Technical Service Bulletin

Cobra Motorcycle Mfg.

TSB1004: 2004 King & CM 50 engine case screws

April 2, 2004

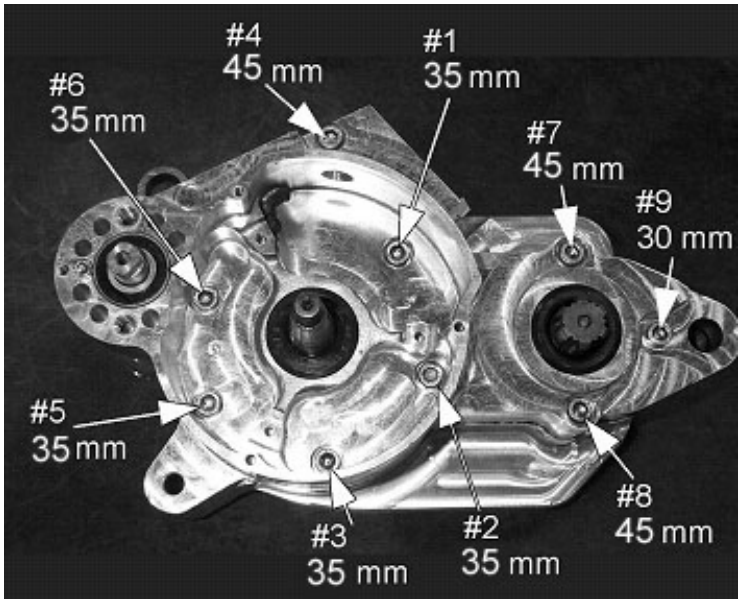
During new product break-in check the tightness of the engine case screws.

If these screws become loose the machine could experience an air leak and/or an oil leak.

Proper torque is 80 in-lb (9 Nm).
